Access Compliance Report Public Rights-of-Way (Curb Ramps)

Intersection ID: 31516 Main Street: SUNMAN RD **Cross Street: VERESE CT** Location: NW Initial Pass/Fail: Pass **Overall Compliance: No**

Ramp Type: BlendTrans1

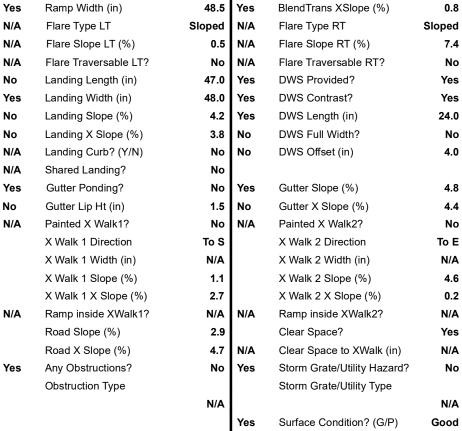
Possible Solutions: Remove & Replace Curb Ramp With Two New Directional Ramps or Equivalent. Remove & Replace Gutter. Surveyor Notes: N/A PROW/ADA: Not Found, R304.2.1, R304.2.2-Perp, R304.3.2-Para, R304.5.3, R305.1.4, R305.2, R302.7.2
